**RE: RESPONSE TO INFORMATION REQUEST FOR OPW/2020/650  
EXTERNAL WATER MAIN RELOCATION ASSOCIATED WITH STAGE 1 OF THE  
VANTAGE, YATALA INDUSTRIAL DEVELOPMENT**

**Property: Lot 501 on SP295994 – 60 Stapylton Jacobs Well Road Stapylton QLD**

We act on behalf of the Applicant, Frasers Property Australia Pty Ltd, and provide the following response to Council's Information Request dated 8 June 2020. Given the nature of the response, the Applicant considers this to be a full response to the information request.

- EXISTING 225Ø WATER PIPE TO BE REMOVED
- EXISTING 225Ø WATER PIPE TO BE ABANDONED AND GROUT FILLED IN PLACE. WATER MAIN TO BE RETAINED ON GCWW'S AS CONSTRUCTED RECORDS. NOTED AS ABANDONED FOR DTMR FUTURE REFERENCE.

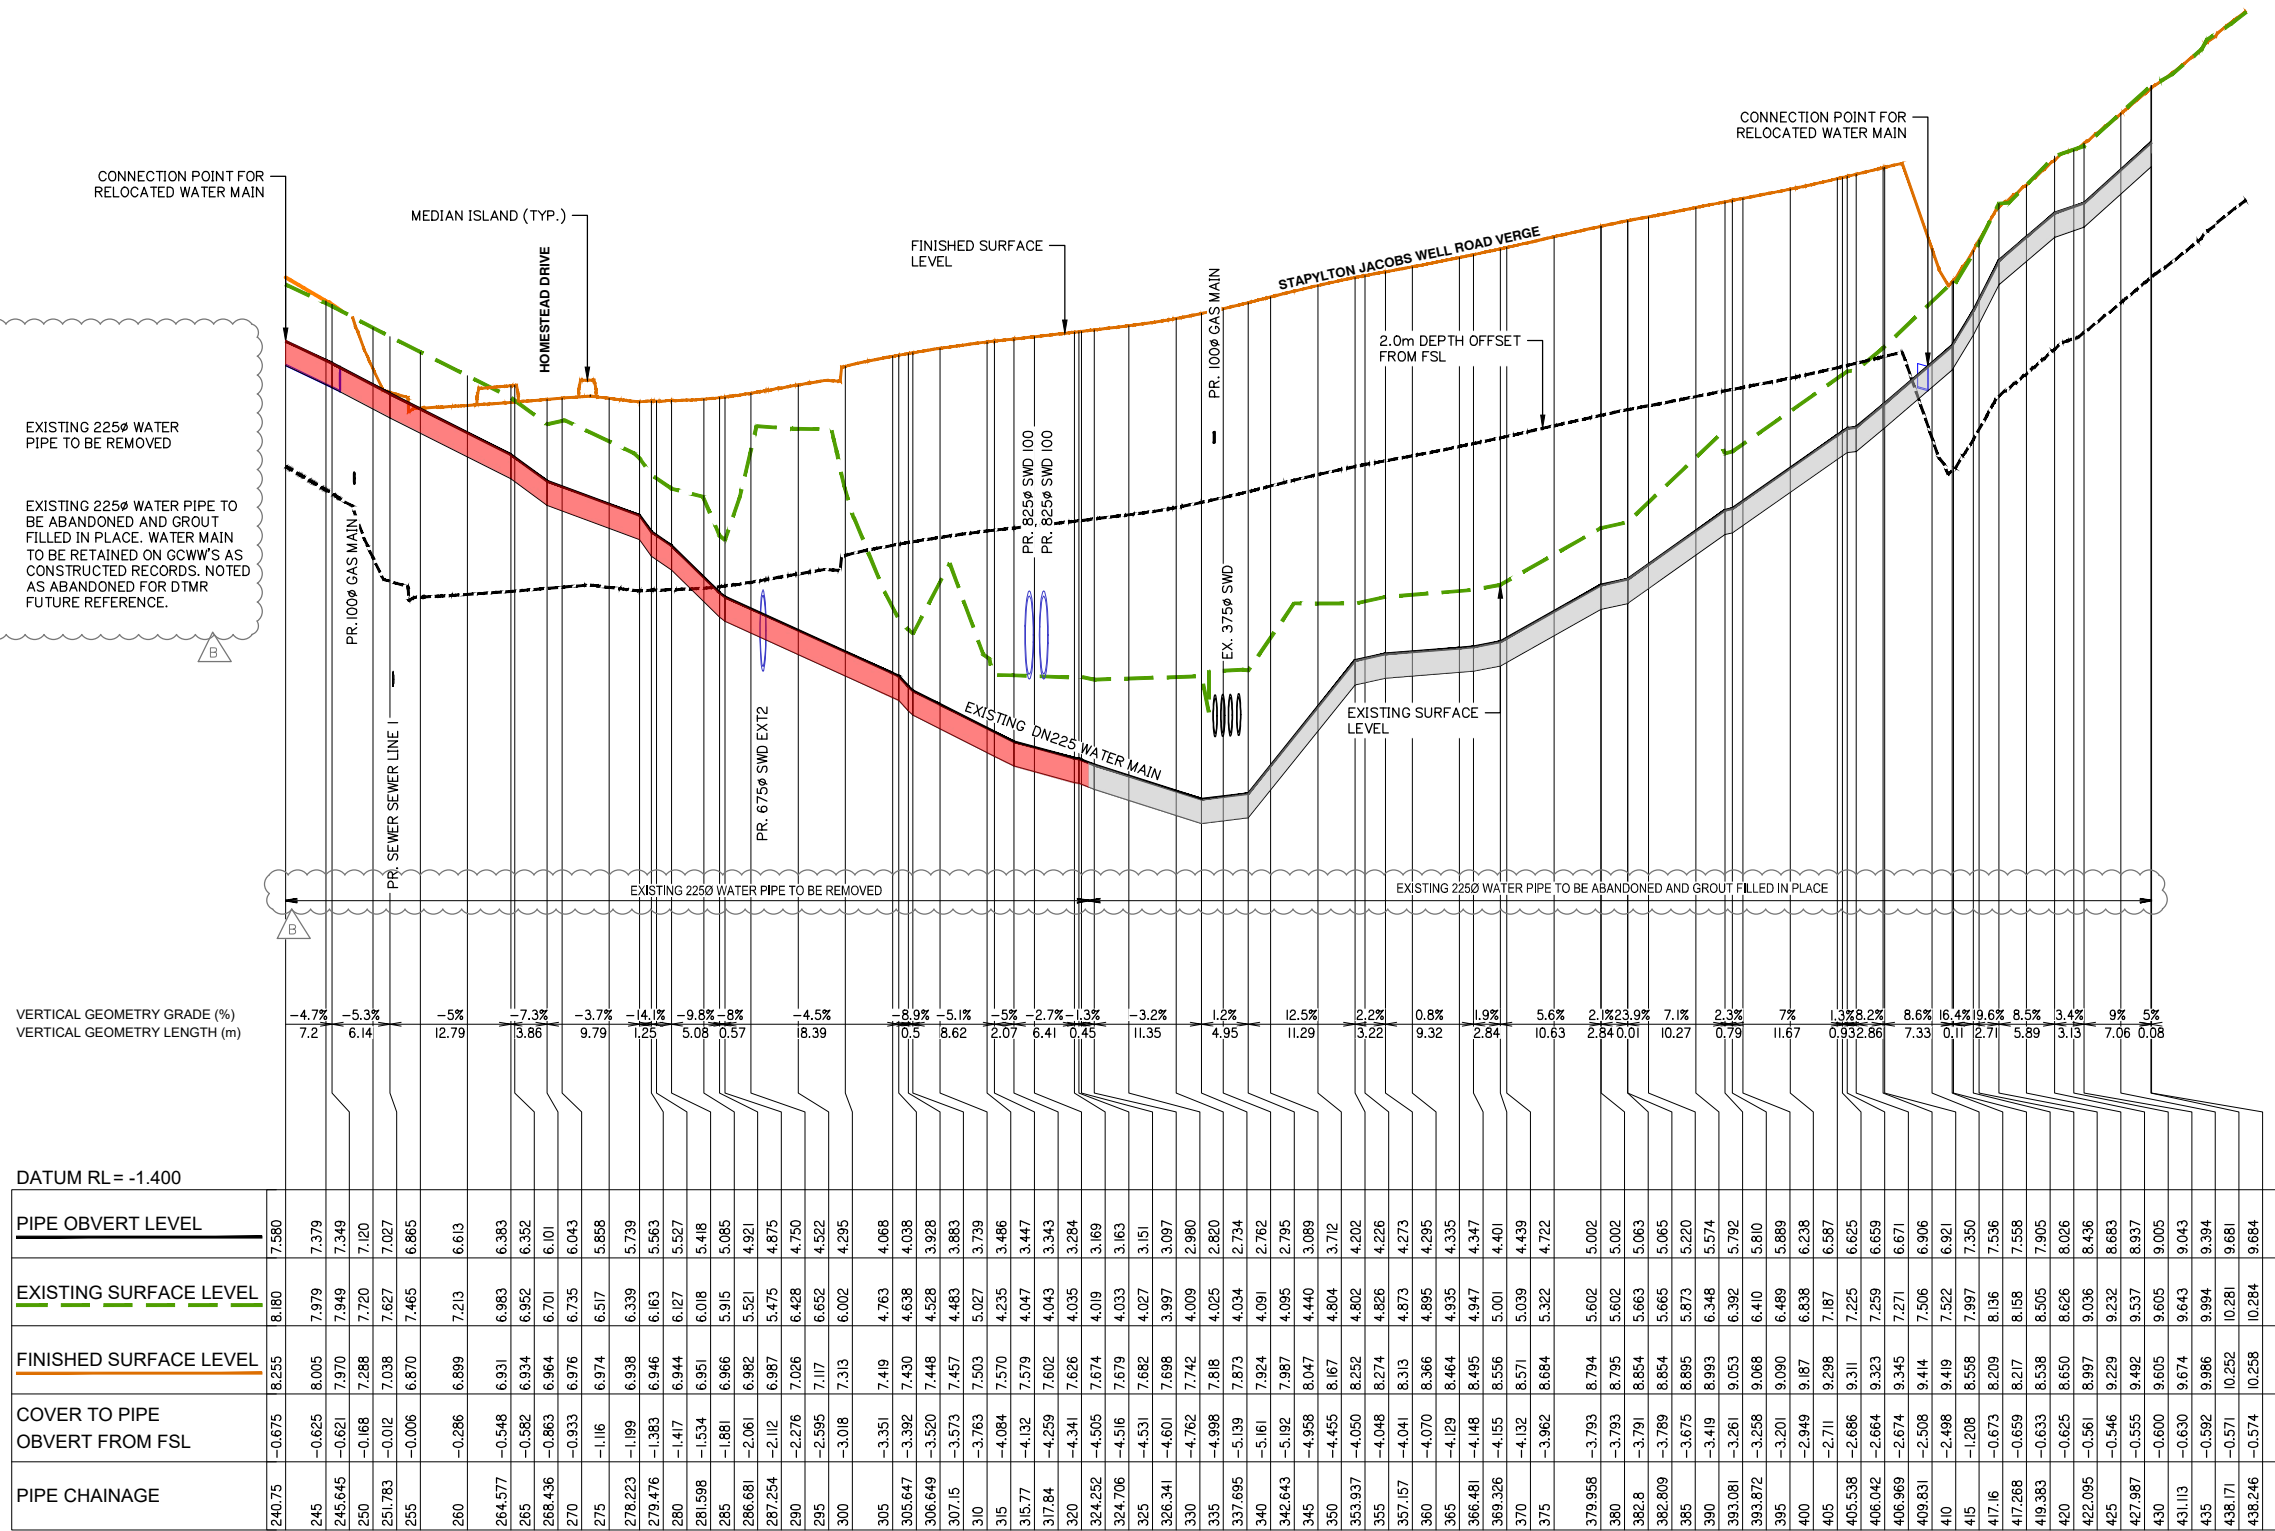
- 7      *Update Section 1 notes regarding the watermain to abandoned following confirmation from TMR that it can remain in place, rather than removed.*

The Section 1 notes regarding the watermain demolition / abandonment have been updated to reflect DTMR's advice. The revised engineering drawing set containing this updated plan is contained with **Attachment 3**.

LONGITUDINAL SECTION – DESIGN WATER MAIN LINE 1

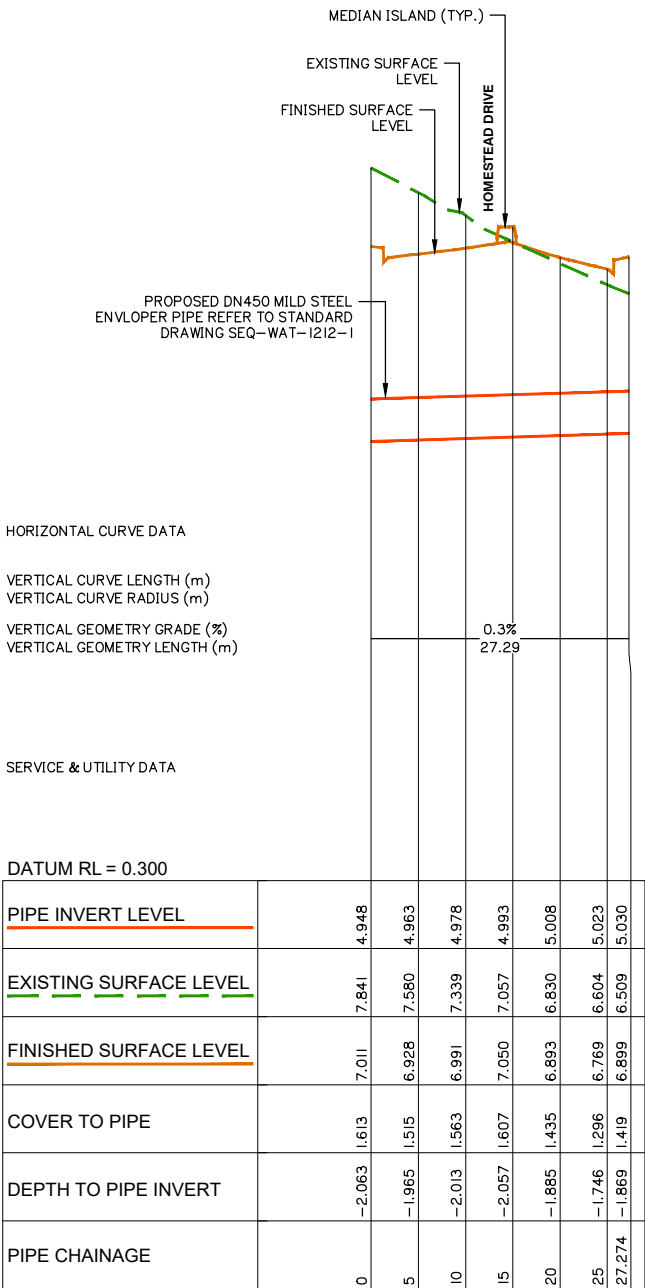
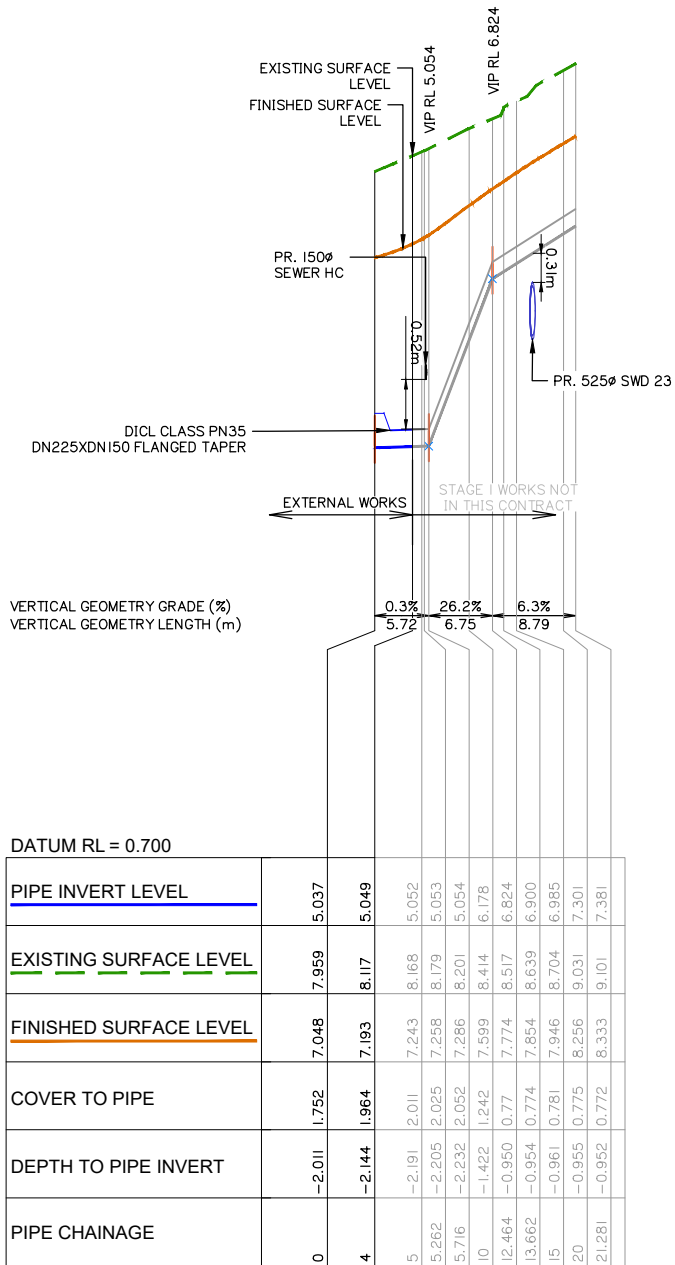
10 *Amend PVC-M to DICL PN35*

11 *Provide and show any required vertical bends and notes for any thrust blocks.*

No amendment has been made based on GCWW's advice that PVC-M can be utilised for the works.

Drawing 011 has been updated to show the required vertical bends and thrust blocks as per Council's request. The revised engineering drawing set containing this updated plan is contained with **Attachment 3**.
